RE: Temet USA Inc.  
Mail Control Number 021676

This letter is in response to our June 14, 1995 telephone conversation regarding an application for registration of the Environics Sensor Unit to be distributed to persons exempt from license by Temet USA Inc.

RE: Application for Registration of Environics Oy Sensor Unit  
Mail Control Number 021676

**Request for Radiation Safety Evaluation and Registration**  
**of the**  
**Sensor Unit Chemical Agent Detector Module**

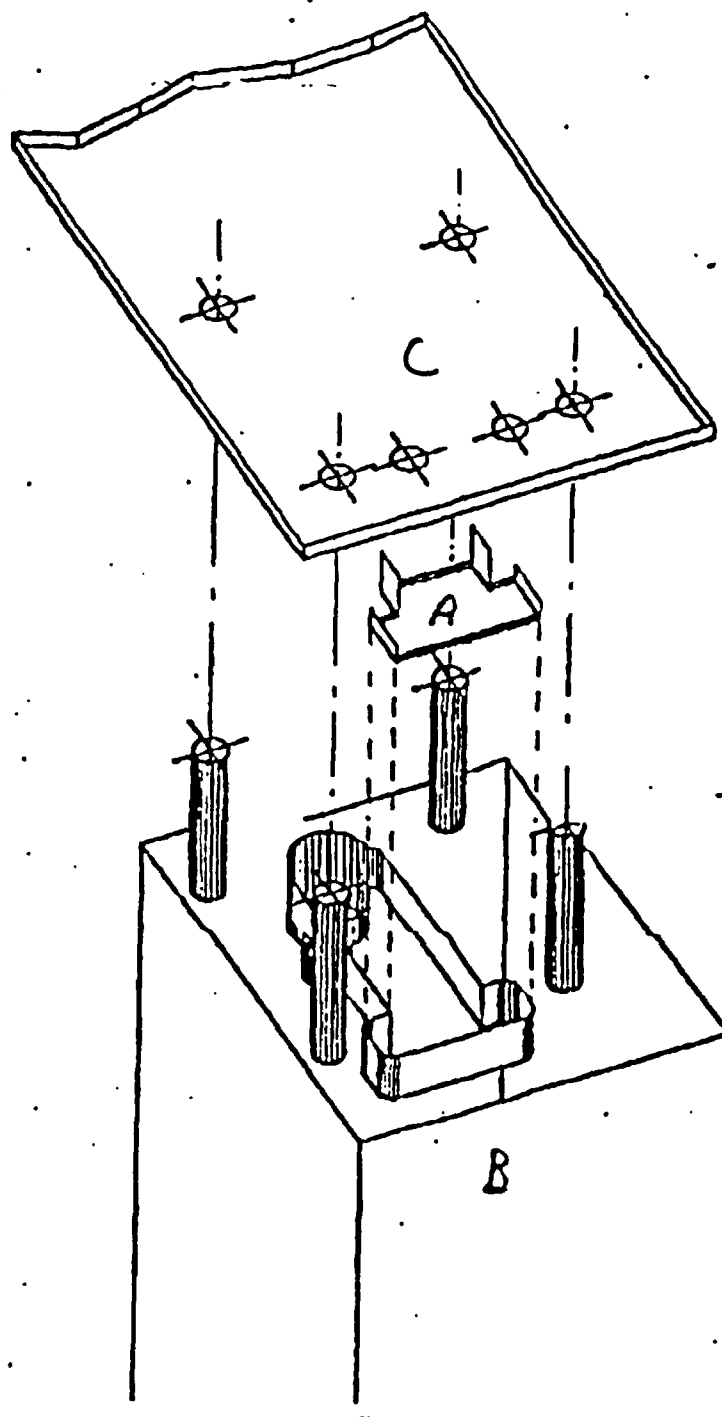
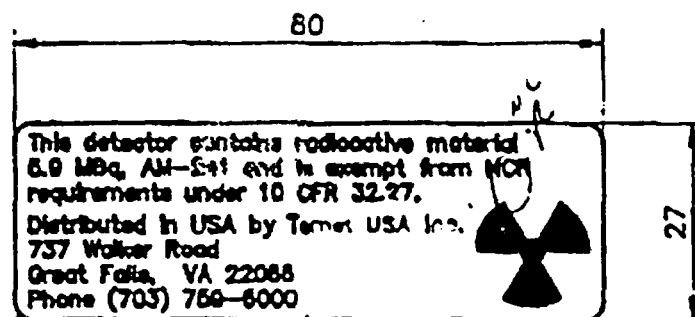
2) The labeling shall contain the text in Section III.C. of our application dated 31 May, 1995. Please disregard the label artwork showing different text.
